SERVICE INSTRUCTION

Change of the tightening torque procedure for the installation of cylinder heads for ROTAX® Engine Type 912 i, 912 and 914 (Series)

ATA System: 72-00-00 Engine

Fig. 1

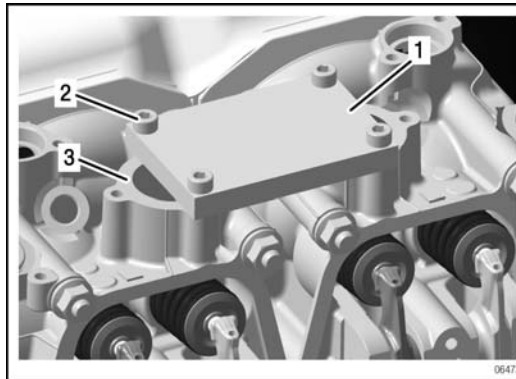
Step	Procedure
1	Raise the cylinder until the centring collar of the cylinder engages in the cylinder head. See latest Maintenance Manual Heavy, chap. 72-00-00.
2	Clean and degrease all threads of studs. NOTE: M8 collar cap and M8 collar nuts also must be clean and free from residues.
3	Lubricate the contact area for the M8 collar cap nuts with grease. NOTE: No grease for M8 collar nuts contact areas!

Step	Procedure
4	Hand-tighten 2 M8 collar cap nuts and 2 M8 collar nuts evenly (maximum 5 Nm/44 in.lb), until cylinder head rests on cylinder.
5	Attach the cylinder aligning tool part no. 877263 to the intake flange of the cylinder heads with 4 M6x25 Allen screws and tighten to 10 Nm (88 in.lb.), see figure 1. NOTE: This aligns the cylinder heads to ensure a flat support for the intake manifold.
6	Tighten the nuts in torque sequence (see figure 2) following these steps: Step 1: all M8 collar cap nuts and M8 collar nuts with 10 Nm (88 in. lb.). Step 2: all M8 collar cap nuts and M8 collar nuts with 30 Nm (-5 Nm)(265 in. lb.) (-44 in. lb). NOTE: Perform step 3 sequentially for each cylinder head nut one at a time following the torque sequence in figure 2. Step 3: Loosen each M8 collar cap nut or M8 collar nut 360° then tighten to 10 Nm (88 in. lb.) + 150°.
7	Loosen 4 Allen screws M6x25 and remove the cylinder aligning tool.

Fig. 2

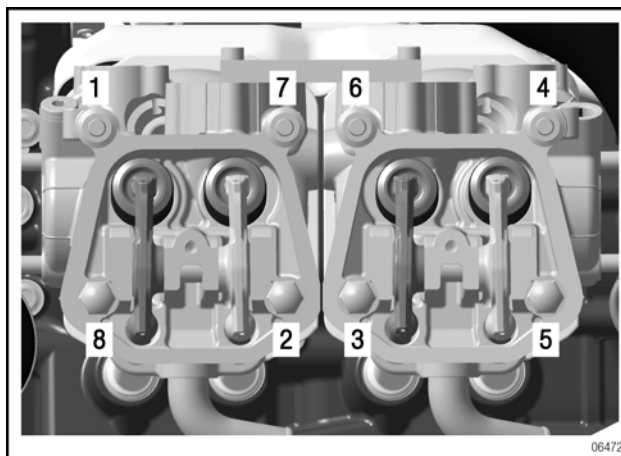
NOTE: The installation and tightening of a single cylinder head or any individual cylinder head nut is not allowed. The entire procedure to torque both cylinder heads together in one torque sequence must be performed.
